From: Pratap Singh <psingh@ksinghengineering.com>
Sent: Friday, September 22, 2023 5:43 PM
To: Pfeiffer, Jane K - DNR
Cc: Shane LaFave; Que El-Amin; Robert Fedorchak; Robert Reineke; Angy Singh
Subject: FW: Community Within the Corridor (CWC) - East Block (02-41-263675) - Comments on Soil Sampling Plan
Attachments: Figure 5. Sampling Locations.pdf; Figure 4. North Mechanical Room Additional Excavation Area.pdf
Follow Up Flag: Follow up
Flag Status: Completed

COMMUNITY WITHIN THE CORRIDOR - EAST BLOCK

SHEET TITLE: Figure 4. Proposed Area of Additional Excavation (Northern Mechanical Room)

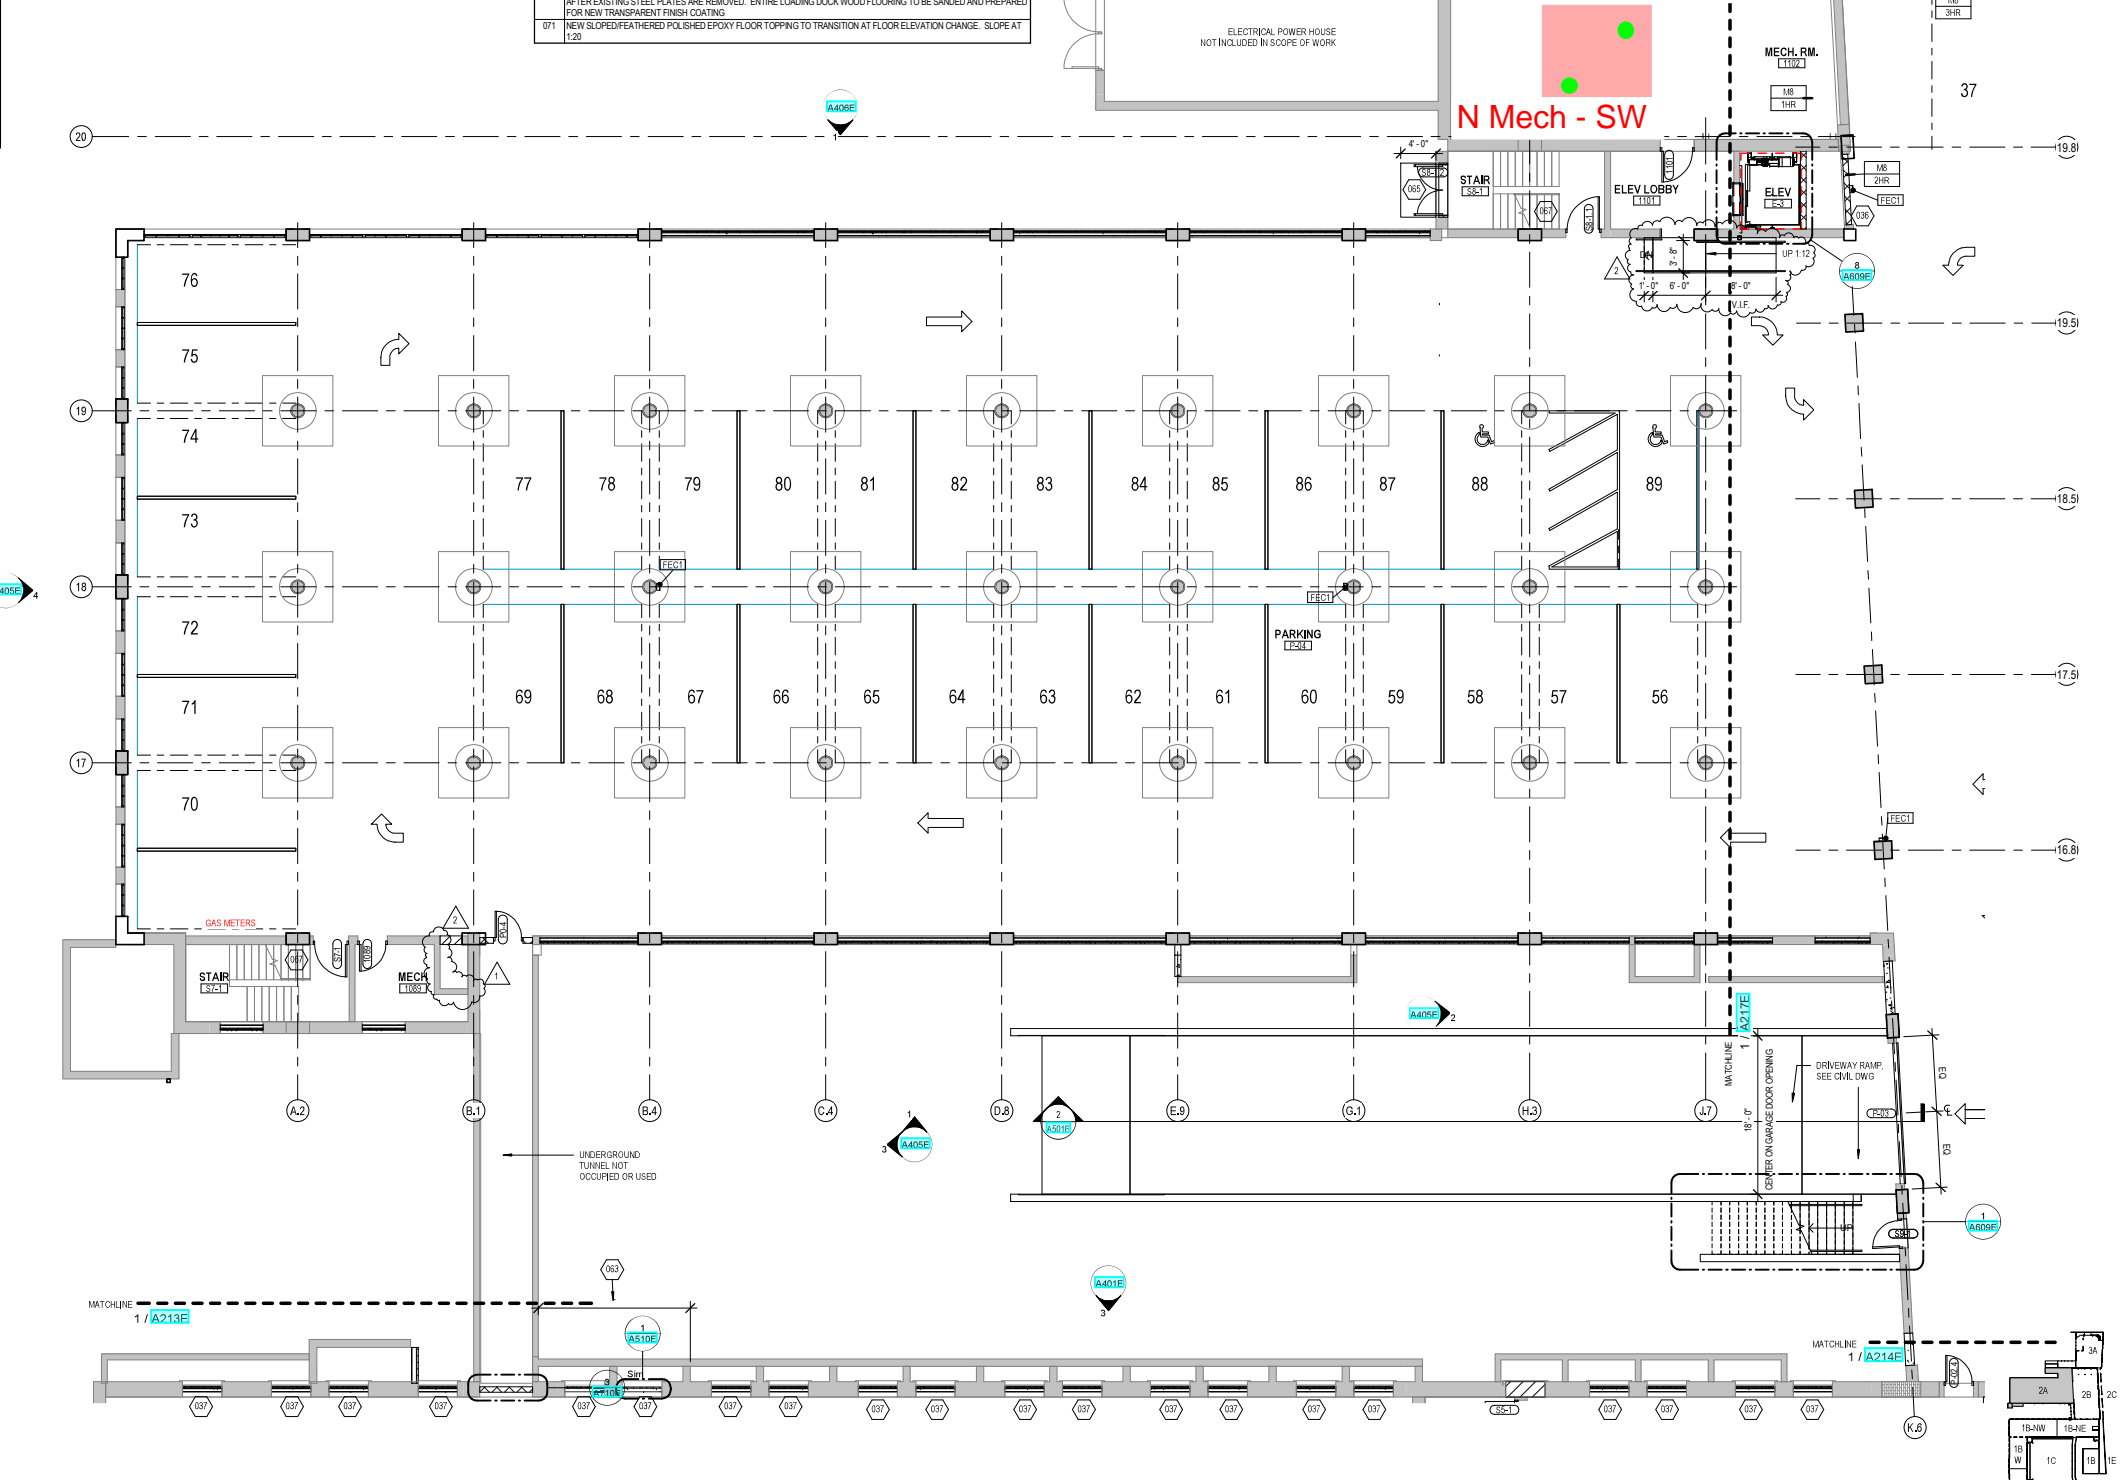
*Northern Mechanical Room samples for hazardous waste characterization will be collected between 1 and 3 feet below soil surface. (Refer to Figure 4 for locations)

Also, per your request, we have added two samples each from the Northern Mechanical Room and Unit 1050 to the sampling program.
